HIGHWAY OBSERVATIONS FOR: 20/01656/CONS

DATE: 9th April 2021

Outline planning application with all matters reserved except for access for a mixed use sustainable urban extension on land to the South West of Milton Keynes to provide up to 1855 mixed tenure dwellings; an employment area (B1); a neighbourhood centre including retail (A1/A2/A3/A4/A5), community (D1/D2) and residential (C3) uses; a primary school and a secondary school; a grid road reserve; multifunctional greenspace; a sustainable drainage system; and associated access, drainage and public transport infrastructure. (Buckinghamshire Council's application 15/00314/AOP).

Summary of advice from Transport Development Management

Figure 1: Forward visibility onto pedestrian crossing

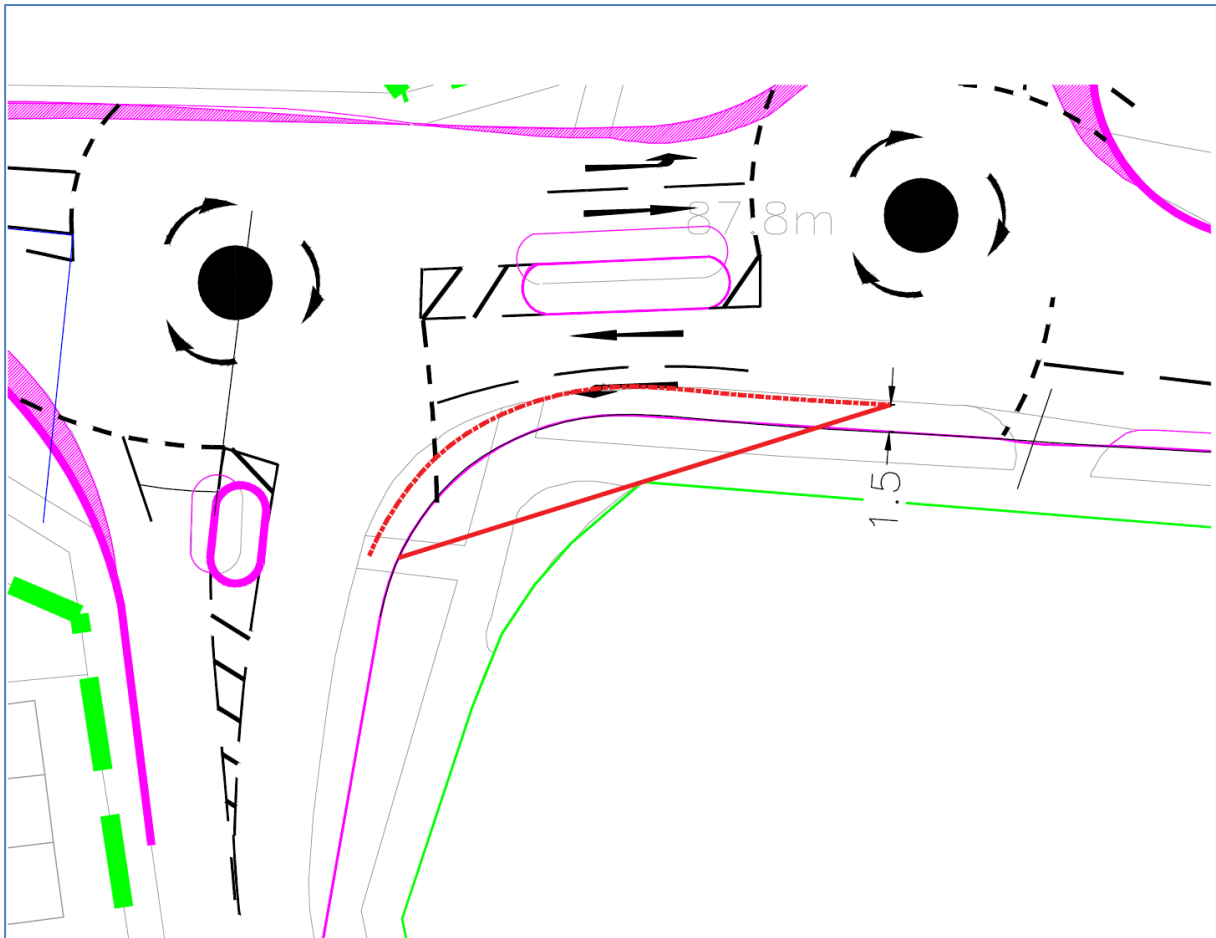
The forward visibility to pedestrians waiting to cross on the eastern side of Newton Road is worsened by the proposals. Taking an MfS SSD (given the speeds and environment), there is currently space to accommodate an approximately 41.9m SSD to the centre of the footway at the crossing. Under the proposals this is reduced to approximately 31.9m (both distances measured along the driver's path), as shown below:

Figure 2: Roundabout exits blocked by HGVs

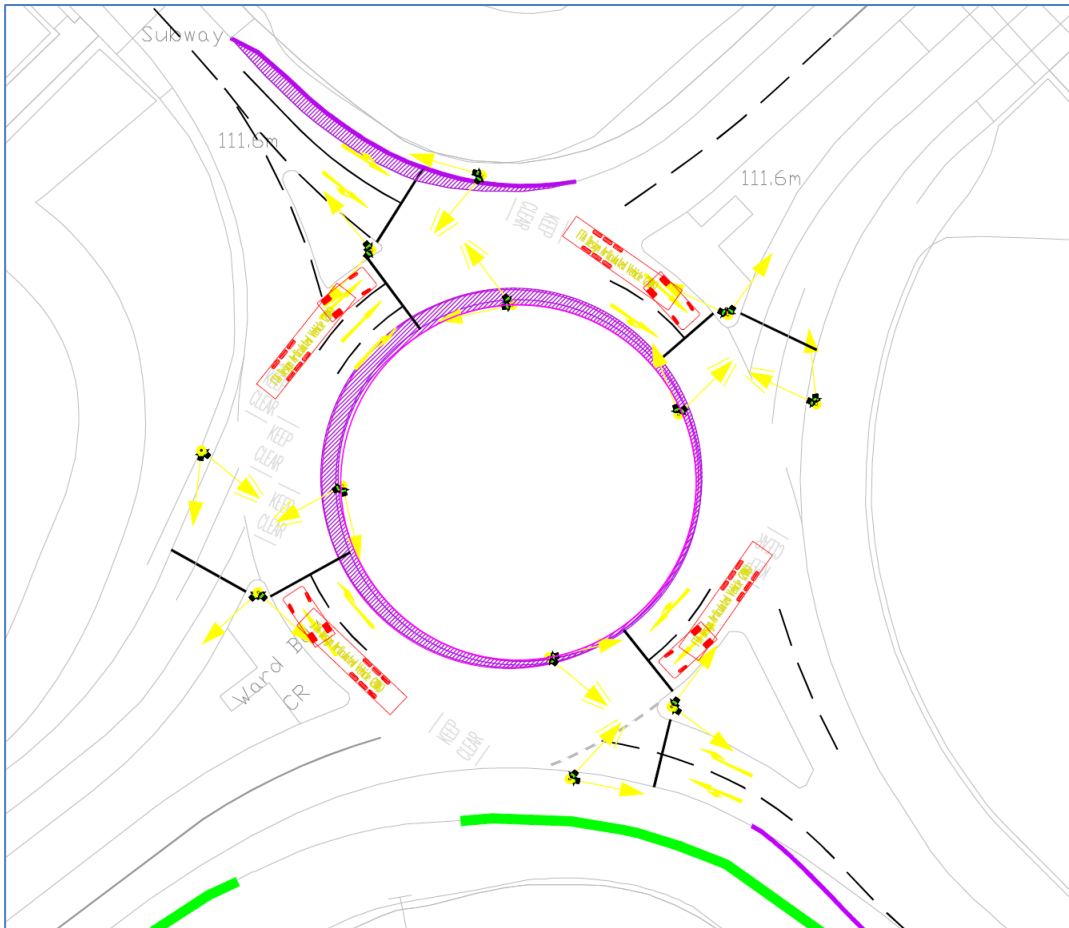
In any case, an articulated HGV stopped at the lights would completely or partially block the exits of the roundabout as shown in Figure 2:

Keep Clear markings have been proposed to mitigate against this potential blocking back. Given that the junction is signalised and would be congested at busy periods, it is unlikely that these markings would be observed by drivers and they are not enforceable.
